Thoughts on the IL strawman

G. Zimmerman 1/18/2021

IEEE P802.3cy > 10 Gb/s 802.3ch Rec Elect Add Crosstalk PHY Task Force (149.5.3)

sedarat_3cy_01_01_05_21.pdf slide 9

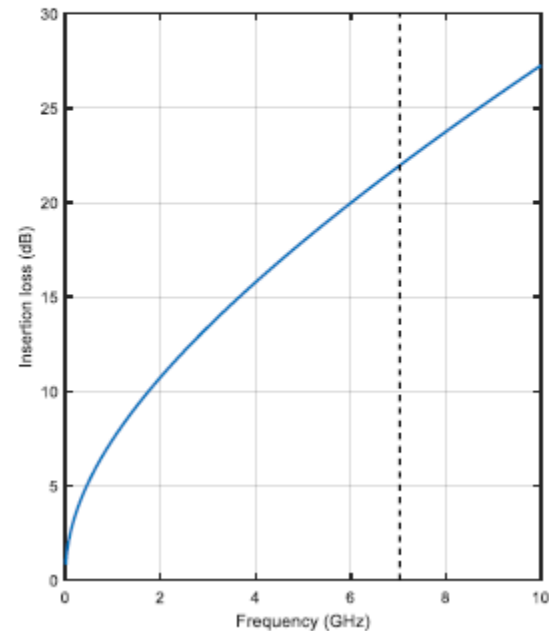
Is Sedarat_3cy_01_01_05_21 margin on top of margin?

- Some issues mentioned in slide 8:
 - PCB loss/materials
 - Loss for connectors
 - Minimum tx power
 - Implementation loss
 - Should this include crosstalk noise?
 - FEC coding gain? (computed directly)
 - Is 5 dB reasonable or overkill?
- Additional issues discussed in TF:
 - Temperature of full cable of 105C vs lower avg. temp not relevant to IL limit line, only to evaluation of cables
- Further potential:
 - -140 dBm/Hz was a PHY complexity trade off, not a hard limit. 3 dB could be had here
 - What margin is considered reasonable in the end? – depends on budgets included
 - Analysis of EMI margin directly

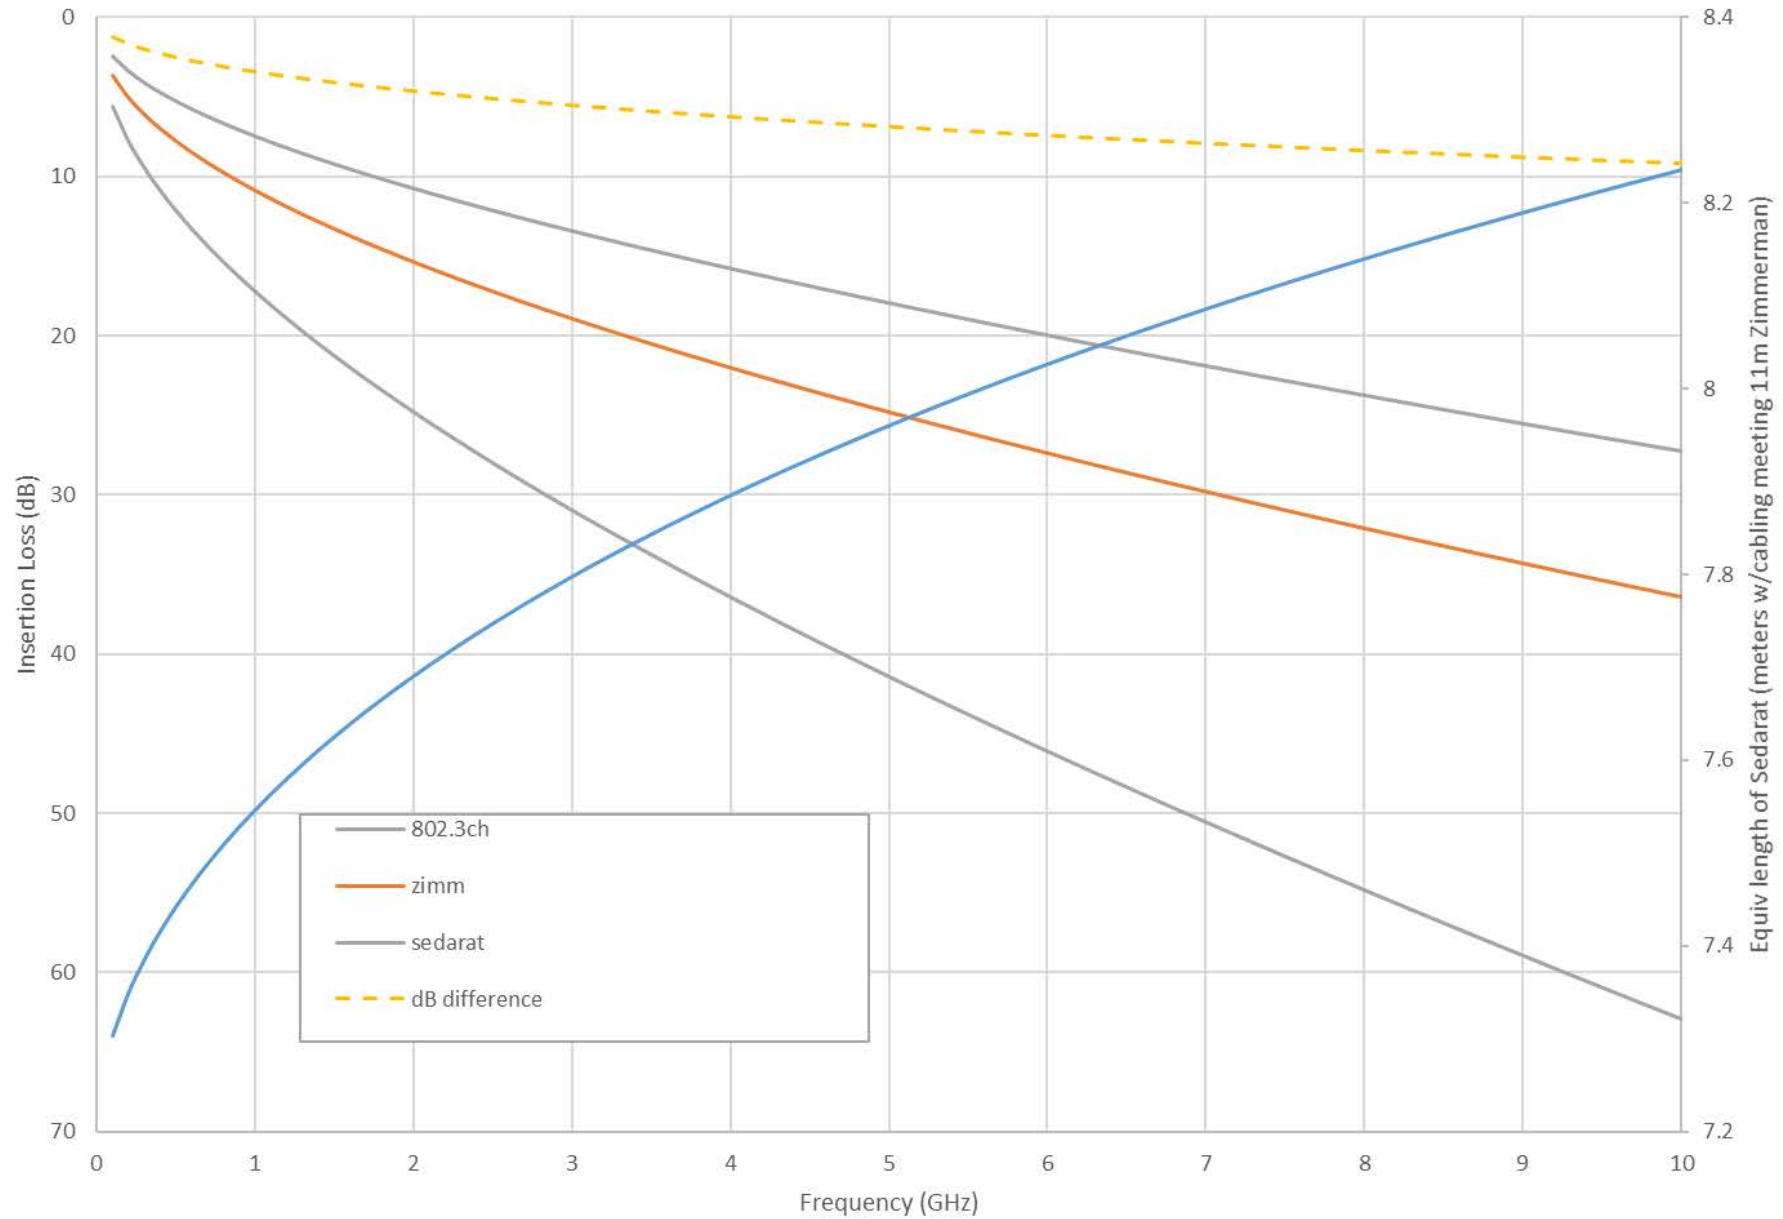
The elevated assumed RX noise relative to other technologies masks losses

Sedarat proposal, existing modeling has MUCH higher noise

- Assumed broadband noise of -140 dBm/Hz over 7.5 GHz
 - -41.25 dBm rms noise (75.0 nW)
 - 2.7 mVrms into 100 ohms
- $1e-12$ (~7-sigma) noise ~19 mV

- 802.3ch alien crosstalk level of -152 dBm/Hz over 3.5 GHz
 - -56.56 dBm rms noise (2.2 nW)
 - 0.47 mVrms into 100 ohms
- $1e-12$ (~7-sigma) -> 3.3 mW

- Alien crosstalk is at similar levels to 802.3ch, -152 dBm/Hz crosstalk adds only 0.3 dB loss (NOT necessarily additive in dB to losses)
- RX noise impulse events mask EMI impulse events 5.7x larger than

A possible path to 11m, single cable

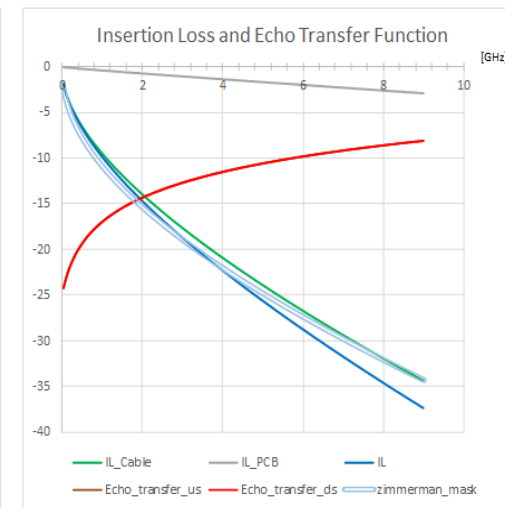
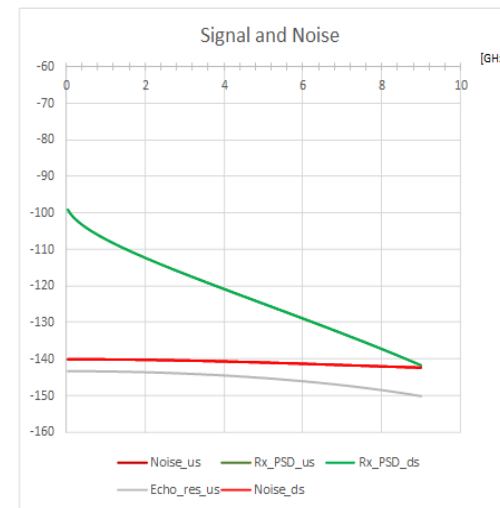
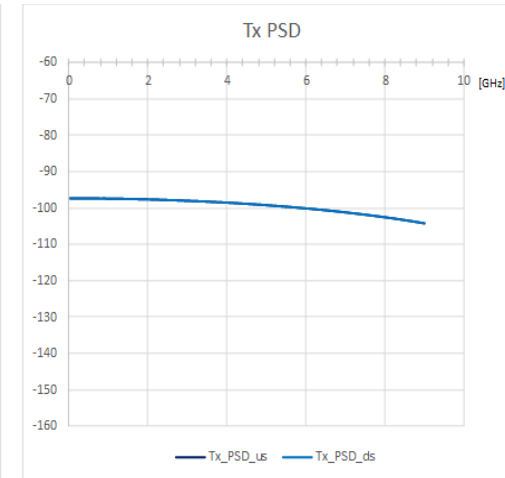
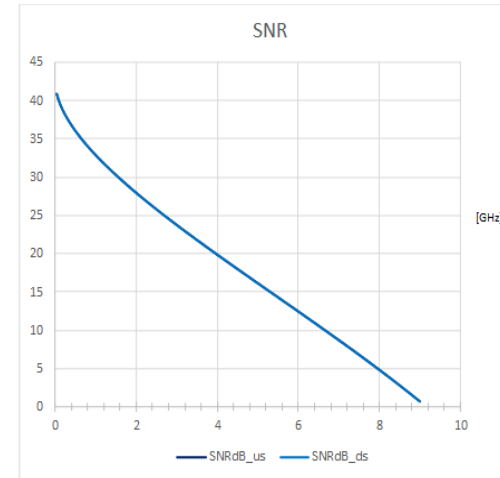
- Start with Mueller SDP cable
 - Mueller_3cy_01_12_01_20.pdf
 - PCB losses modeled
- Improve PHY front end noise 3 dB
 - To -143 dBm/Hz
 - ZOH modeled
- Reduce average temperature to 95C
 - Per Wienckowski profiles
- Maintain 5 dB budget for all implementations
 - (we've lowered the front-end noise)
- Positive margin
 - Still room for improvement on both PHY and cabling

Insertion Loss Limit Lines

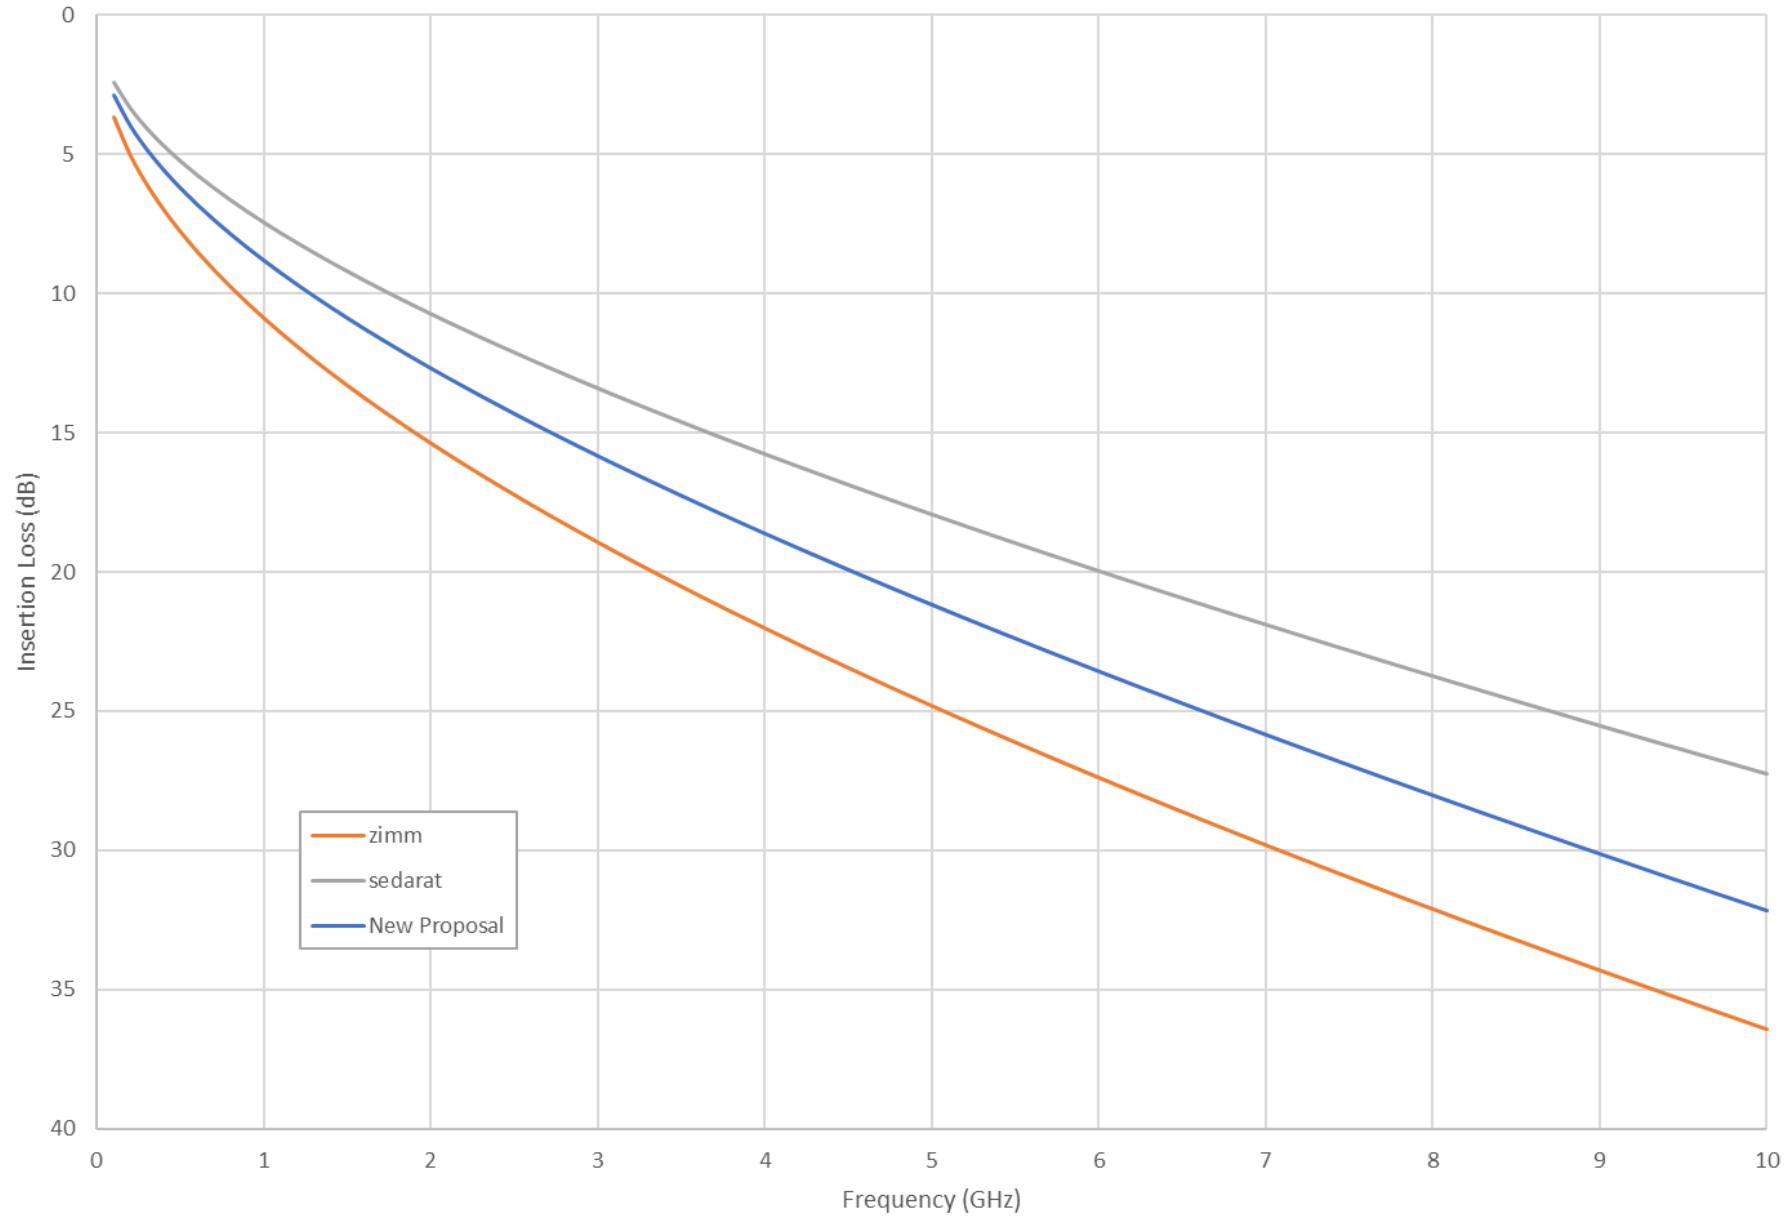
dB IL at 7 GHz	Insertion Loss (dB) vs. freq (MHz)
802.3ch	29.80	$\leq 0.002 f + 0.68 f^{0.45}$
Nov. Strawman (zimmerman):	29.80	$\leq 0.002 (f/2.5) + 0.68 (f/2.5)^{0.45}$
Jan 12 Proposal (sedarat):	21.90	$\leq (6.5/12) \times (0.002 f + 0.68 f^{0.45})$
New Strawman proposal	25.85	$\leq 1.180 \times (6.5/12) \times (0.002 f + 0.68 f^{0.45})$ $= 0.00128 f + 0.435 f^{0.45}$
Mueller_3cy_01_12_01_20 SDP cable @ 95C	26.7 dB	(relaxation from 105C from wienowski, based on model in Jonsson spreadsheet)

- We are NOT ready to adopt baseline
- Economic feasibility demands balancing the relative cost factors between components
- PHY must share the pain – but cannot take all of it
 - Consider both receiver parameters, implementation, and operating margin
 - different vendors will divide these differently
- Recommend establishing a new strawman IL as our target, at least “splitting the difference” between cabling and PHYs
 - Not a baseline, still a strawman
